Supporting Statement for Planning Application Ref 71000

Erection of 17 no. small light industrial units with associated servicing
and car parking

Eton Business Park, Eton Hill Road, Radcliffe

May 2025

Proposed Site Layout: Swept Path
Analysis - Fire Appliance Entering
the Site

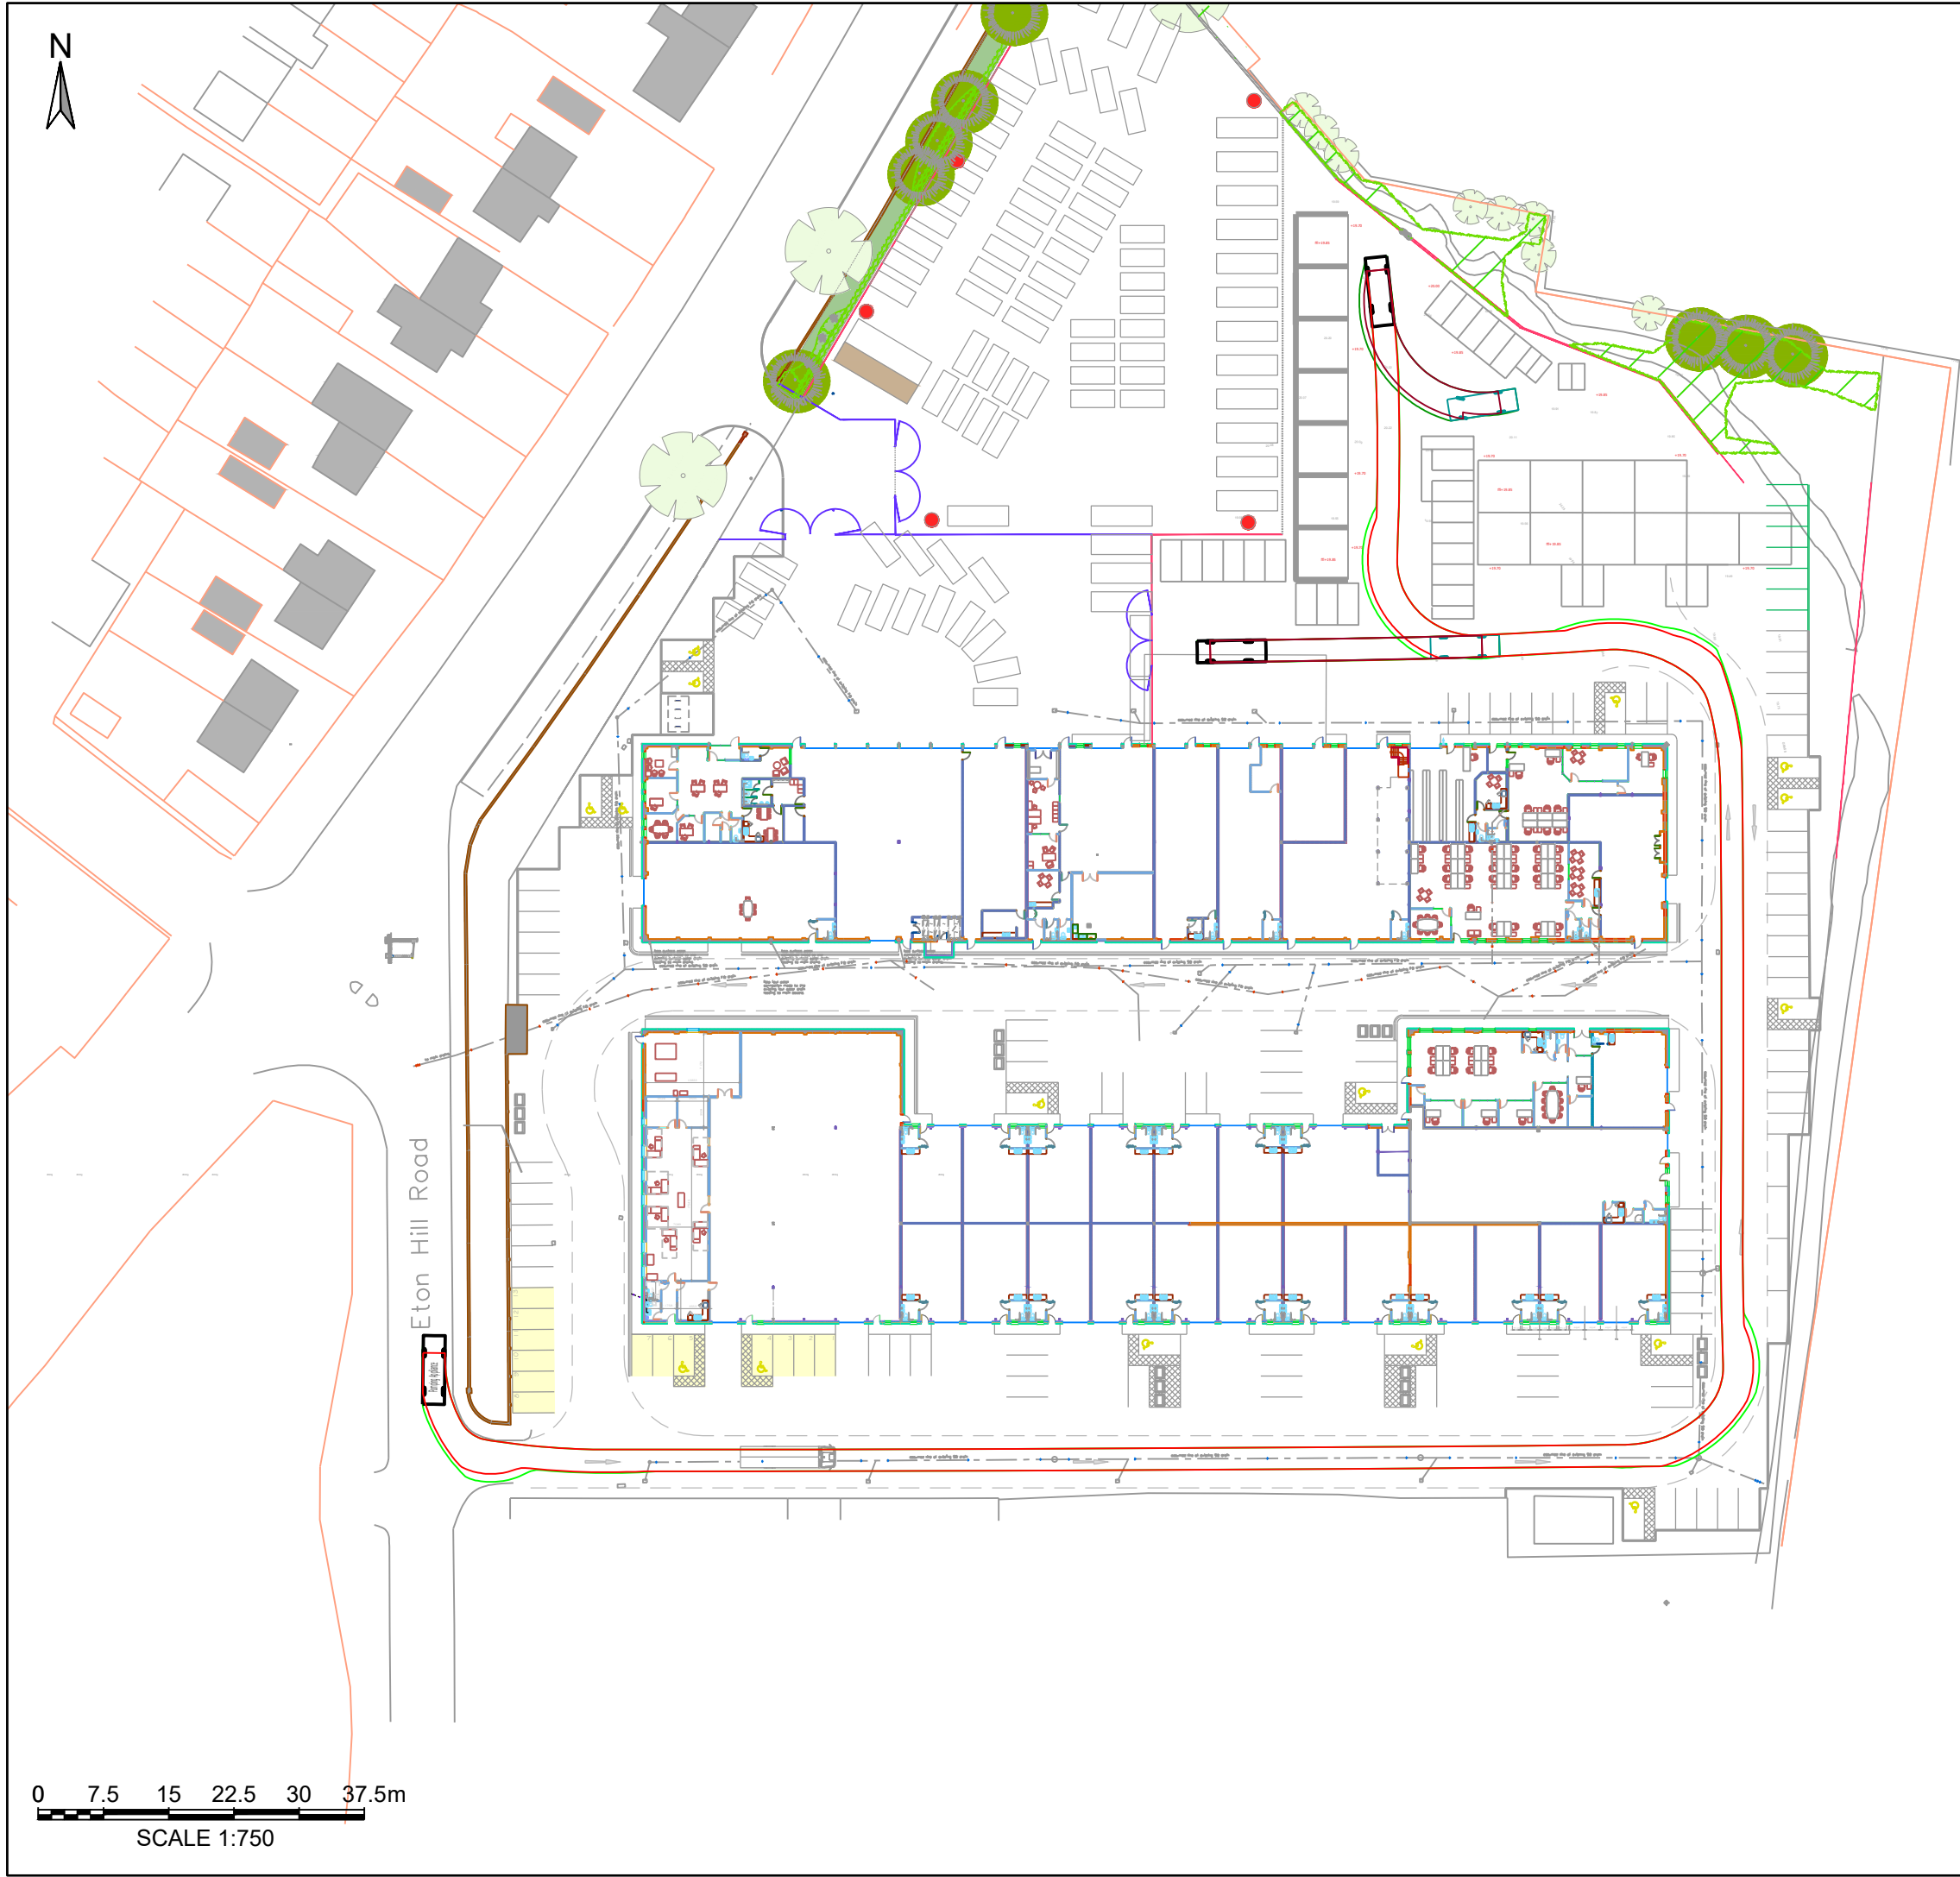
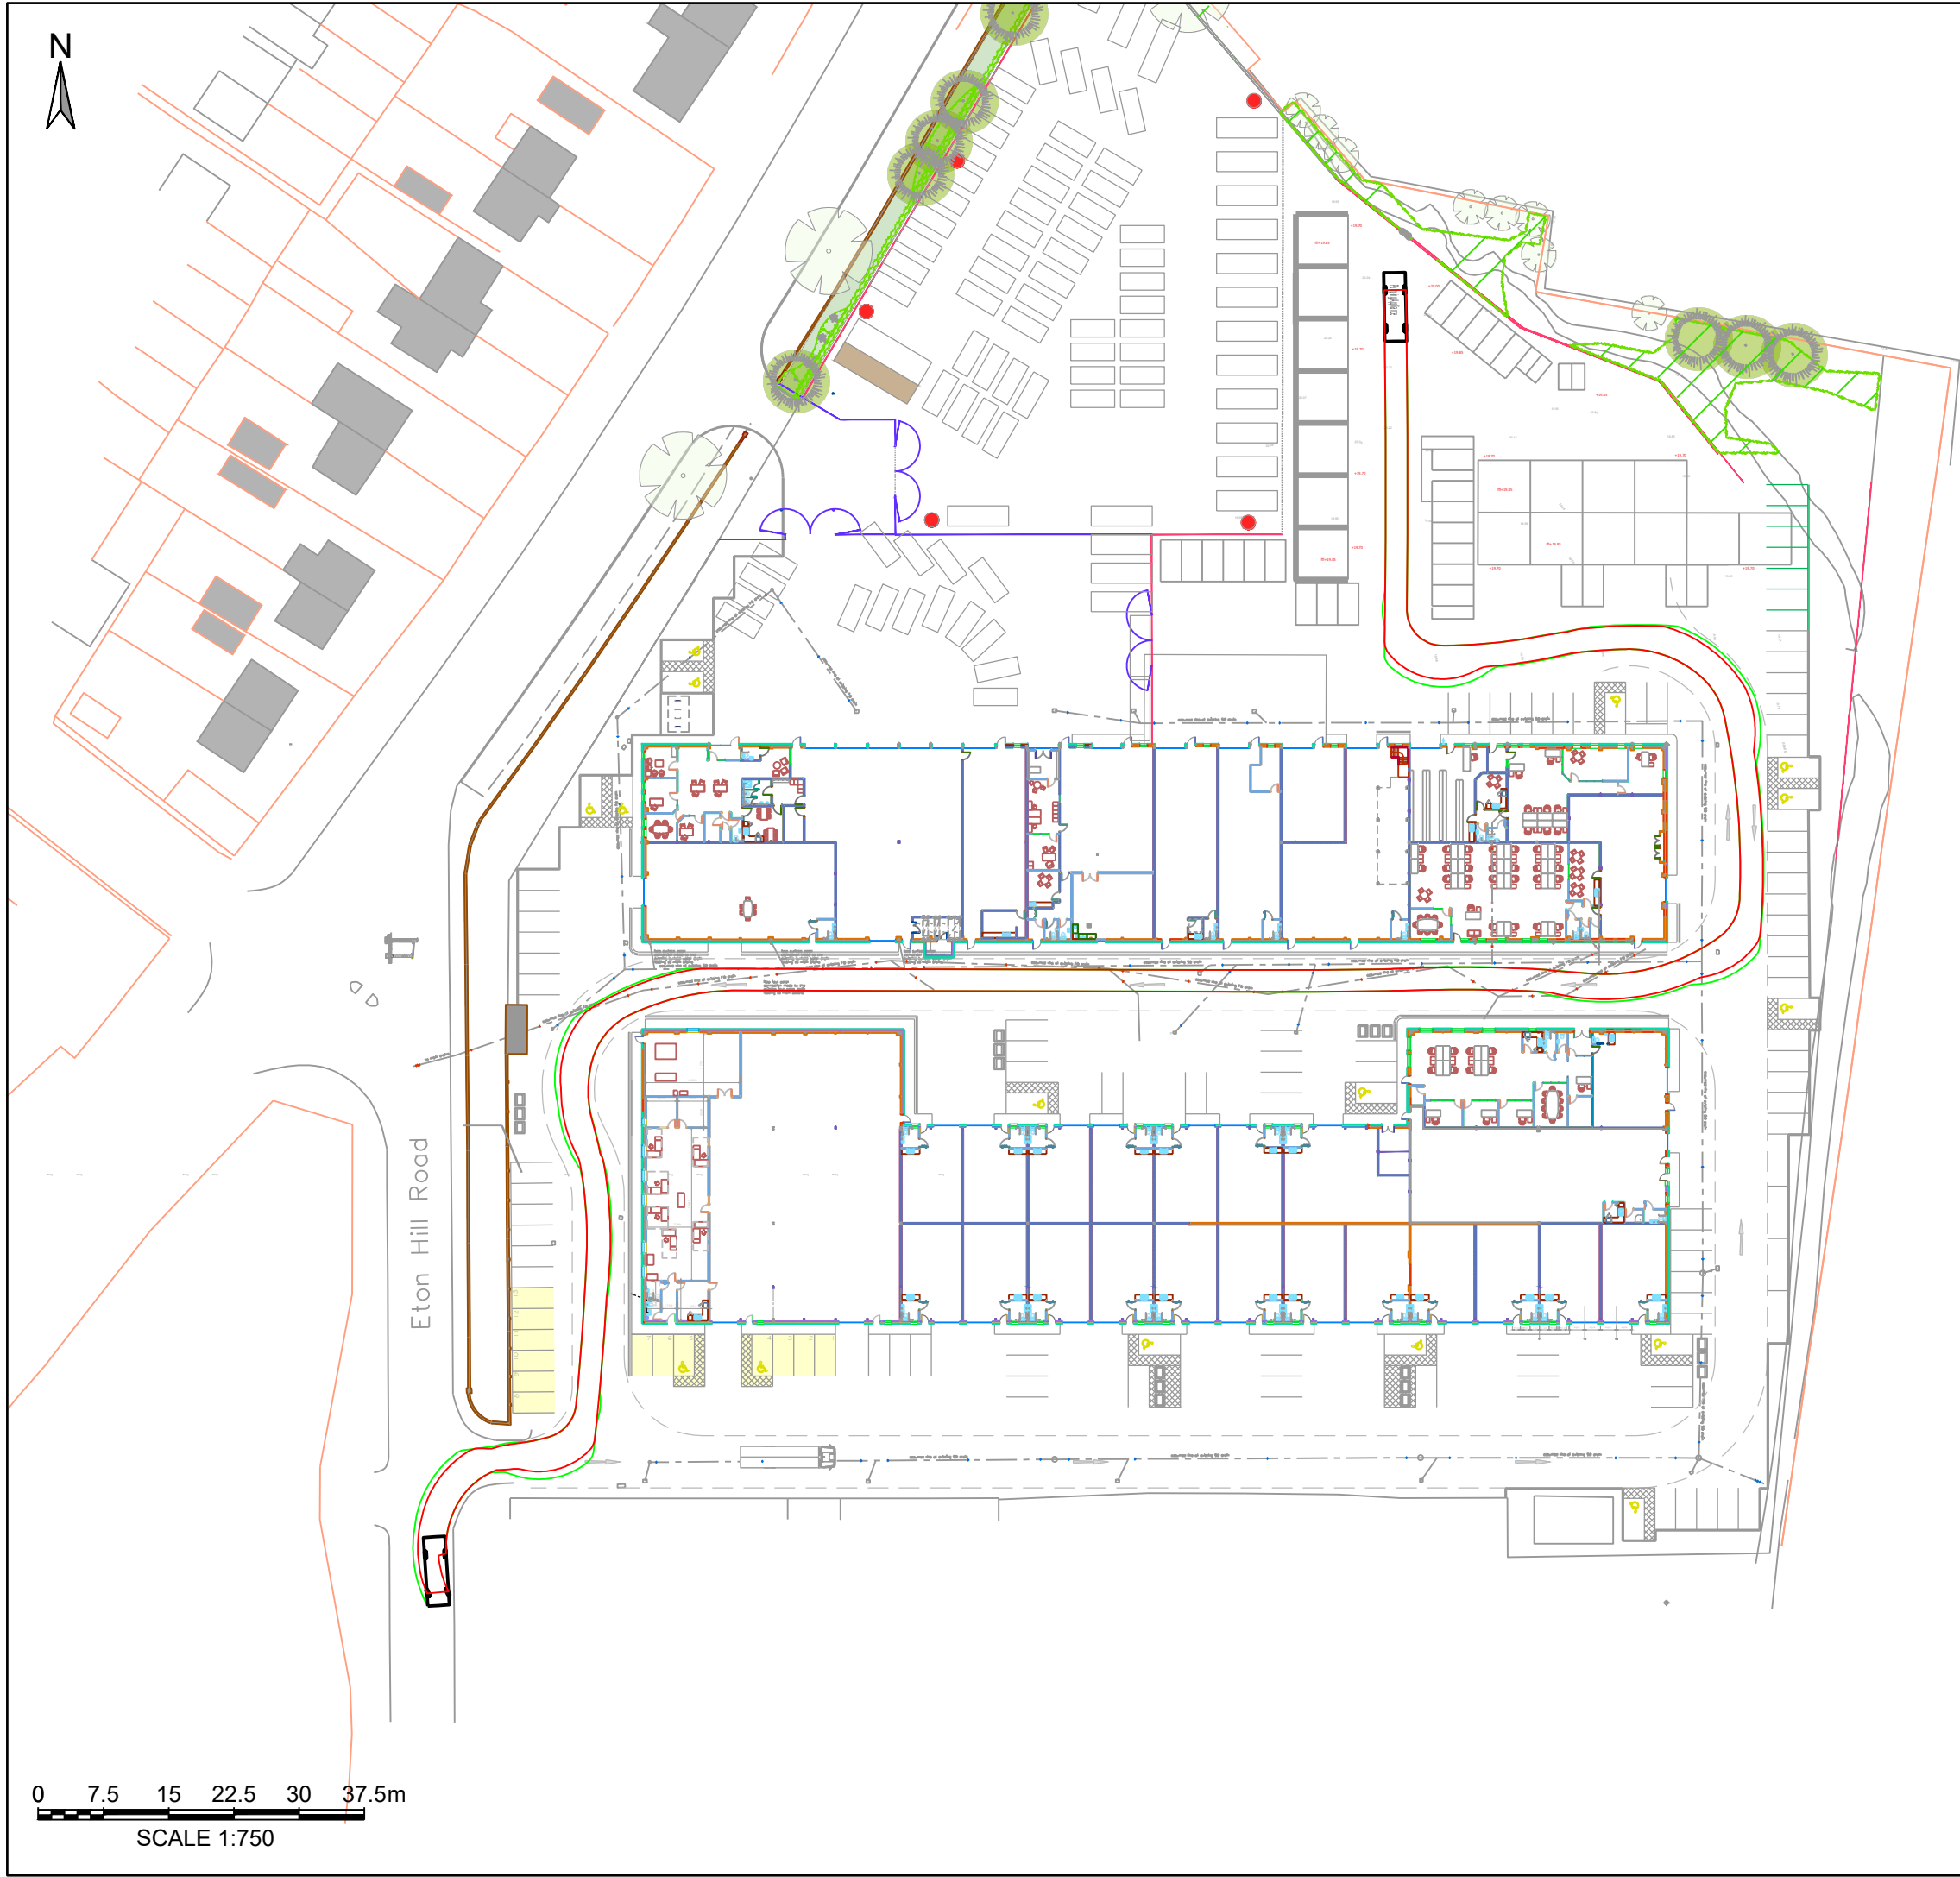
3.15 Statutory Consultees Comments - Please see the response from Greater Manchester Fire and Rescue attached. As it stands the site and its lack of access for a fire engine would render the site unsafe for future occupants. The application cannot be supported on this basis.

As a minimum vehicular tracking needs to be provided to demonstrate the fire service can enter and leave the site in a fire engine and access all proposed units, and a water hydrant needs to be provided close to the site

3.16 *Applicants Response - Please see attached in appendix C the TN2 updated transport note 2 prepared by Tetra Tech which we believe covers all of these queries / comments raised and which has been submitted to the planning officer during the application process.*
